This application has been prepared by Ethos Urban on behalf of The Trustee for JWD Developments Unit Trust pursuant to section 4.55(1A) of the Environmental Planning and Assessment Act 1979 (EP&A Act) to modify State Significant Development (SSD) Consent SSD10321 relating to 89 John Whiteway Drive, Gosford NSW (the site).

SSD 10321 was granted consent on 14 October 2021 and relates to the construction of a residential flat building. Specifically, SSD 10321 was granted approval for the *construction of a residential development comprising four residential flat buildings to accommodate 201 dwellings, basement car parking, associated landscaping and public domain works.*

A Section 4.55 modification to SSD 10321 (MOD 1) for design development changes to Building A and B and the basement was made on 22 December 2021.

Generally, this modification relates to changes to Building C and D, with some changes in the basement. This modification prevails over MOD 1 to the extent of any inconsistency.

**Figure 6 Approved and Proposed Building C Level 4 Floor Plan**

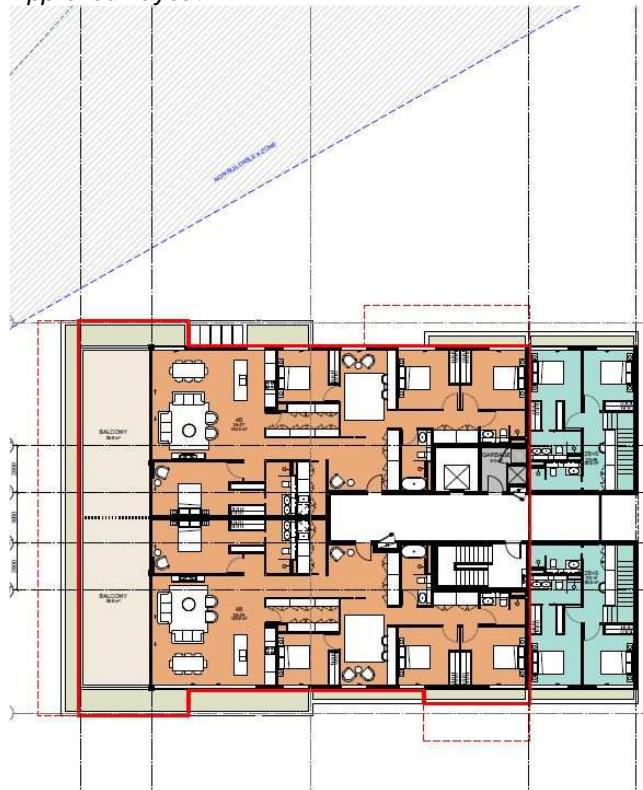
The design review by Marchese Partners found unit layouts and balconies could be improved. All of the internal layouts of apartments in Building C and Building D have been re-planed and continue to be in accordance with the Apartment Design Guide. The re-planed layouts include:

- General review of all units' internal layouts
- Reduced number of units in Building C from 56 to 52
- Reduced number of units in Building D from 68 to 62
- Alterations to internal layout of typical units within Building C and D
- Introduction of two storey apartments for Building C level 7 and 8
- Minor amendments to Building C and D lift core location
- New townhouse typology within Building C

**Figure 6** and **Figure 7** below provides an illustrative comparison between the approved and proposed apartment layouts (Level 4 of Building C and D respectfully). All proposed amendments to the apartment layouts are provided in the Architectural Drawings (**Appendix A**).

**Figure 9 Building C (north elevation)**

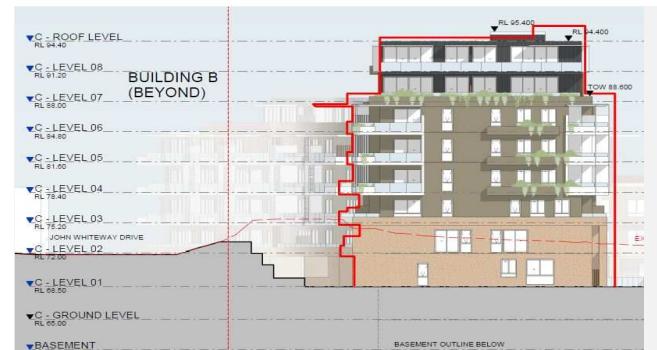
The building envelope is shown at **Figure 8 - Figure 11**. The height of Building C has slightly decreased from RL 94.8m to RL 94.4m.

**Figure 15 Building D2 (south elevation)**

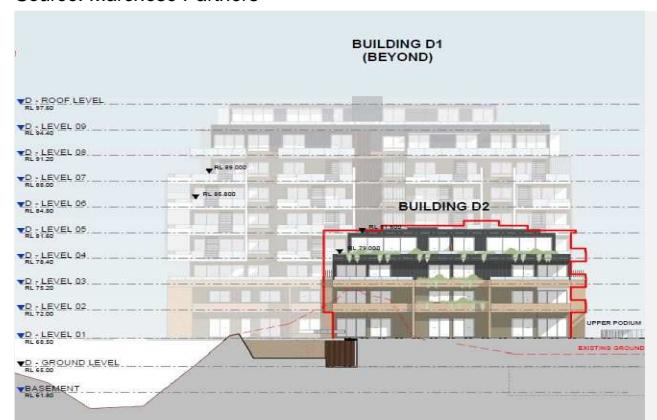
The building envelope is shown at **Figure 12 - Figure 17**. The height of Building B has reduced from RL 99.1m to RL 97.6m.

**Figure 19 Proposed Basement Plan**

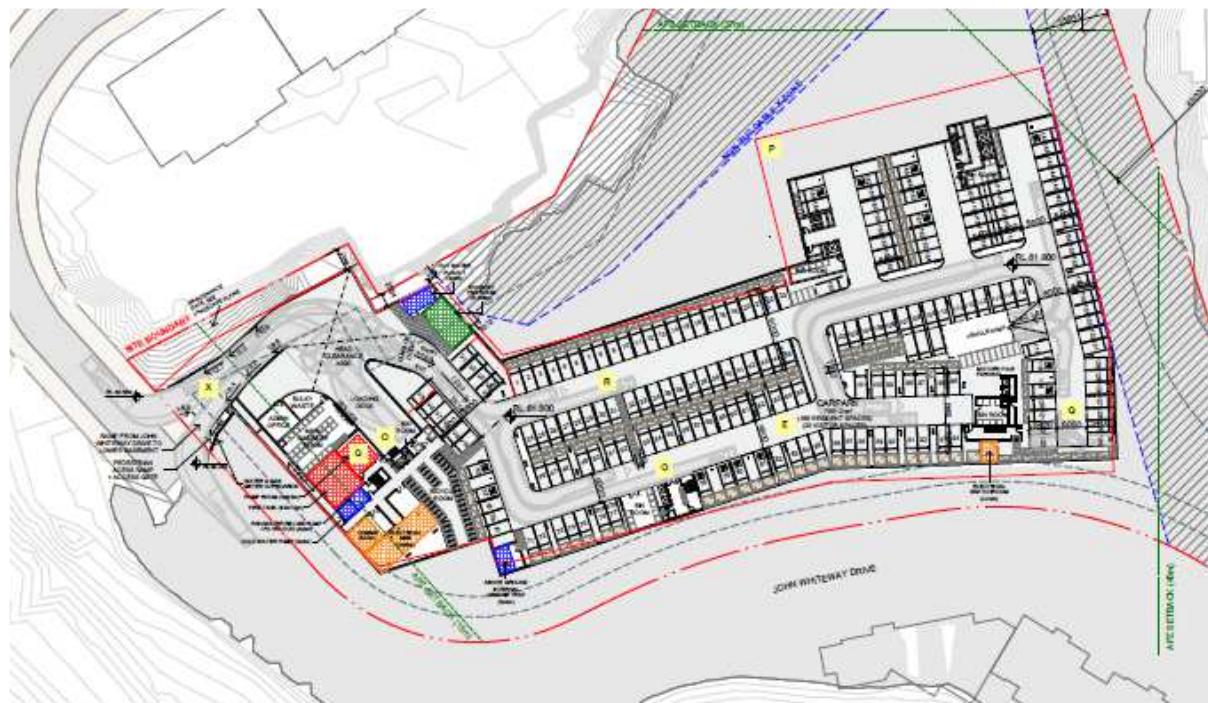
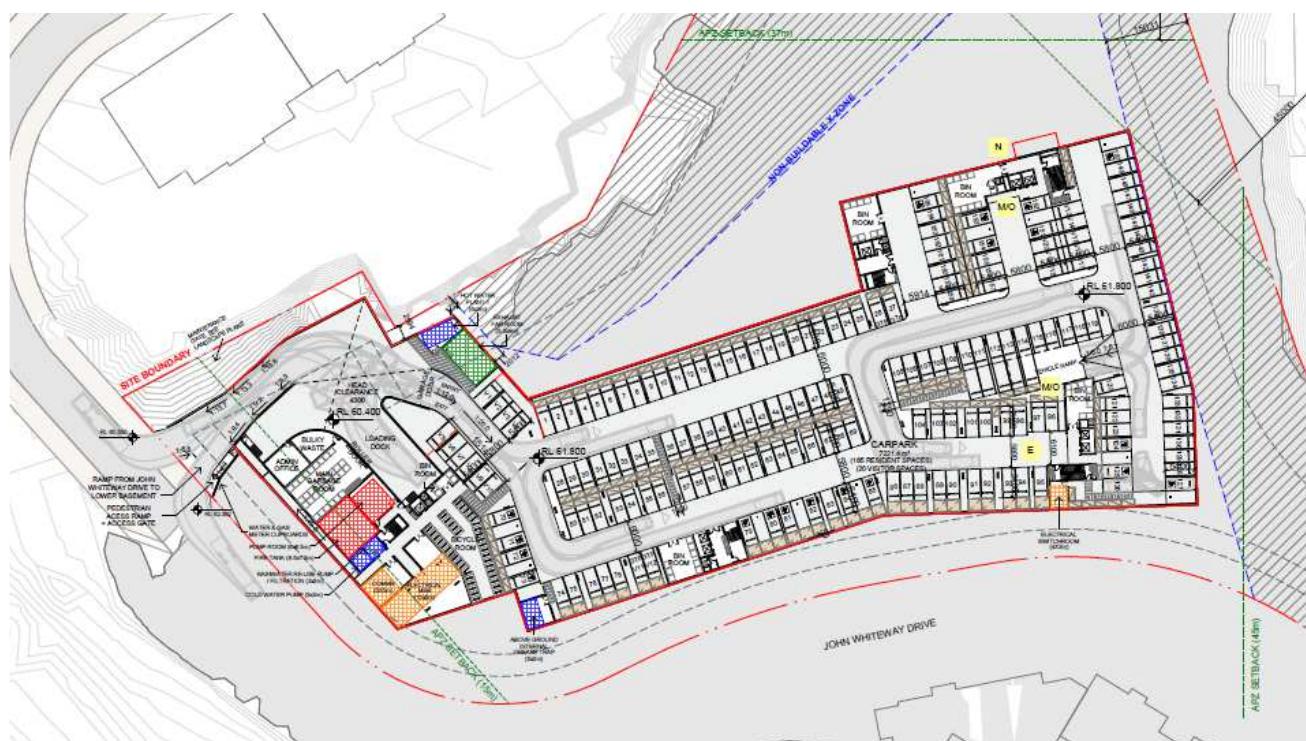
The scale and design of the Basement has been refined to accommodate the broader changes made by this modification. Under MOD 2 the basement extent has been further reduced. A comparison of the Mod 1 and currently proposed basement is shown **Figure 18 - Figure 21**. To reconfirm, no part of the amended basement is within the Non-Buildable Zone.

**Figure 22 Building C Northern Elevation (demonstrating overhanging roof on eastern (left) façade, sandstone expression on podium and other design changes to improve articulation and reduce weathering impact)**

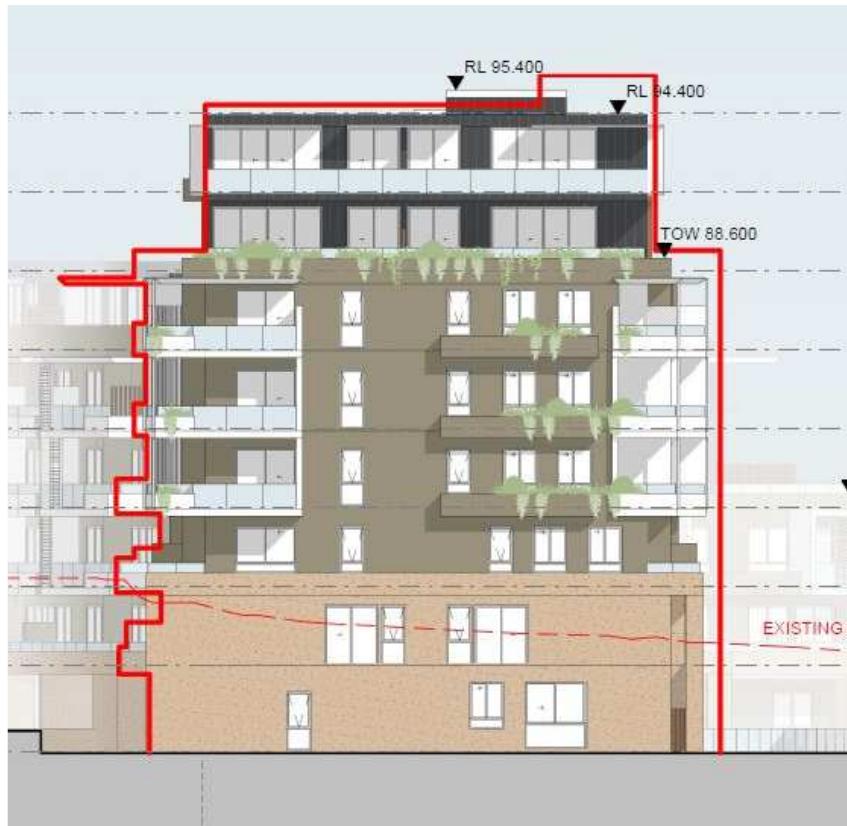
(d) *Redesign of the roof form to Block C to:*

- (i) *include a roof overhang on the eastern façade,*
- (ii) *improve articulation and the proportions of the building profile; and*
- (iii) *provide protection from weathering.*

These design changes are shown below at Figure 22 - Figure 24.

**Figure 24 Proposed Building D Level 1 Plan (demonstrating removal of required units and floor redesign resulting in greater levels of communal and ancillary space)**

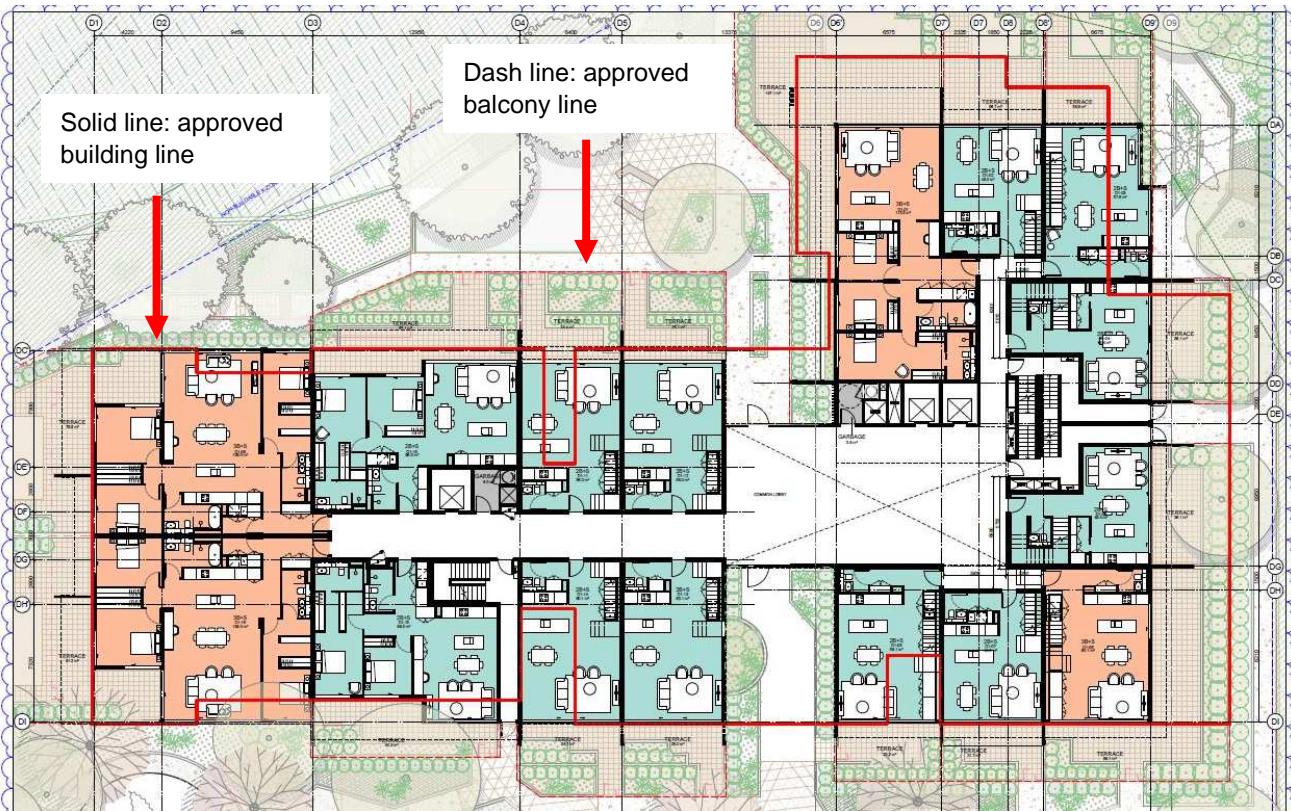
(f) *Due to poor residential amenity, delete the following units within Block D:*

- (i) D1-06
- (ii) D1-07
- (iii) D1-08

(g) *Provide details to resolve the use of the void/vacated area resulting from the design change in condition (f) for use as communal space (indoor or outdoor) or an alternative ancillary to the residential character of the development, to the satisfaction of the Planning Secretary.*
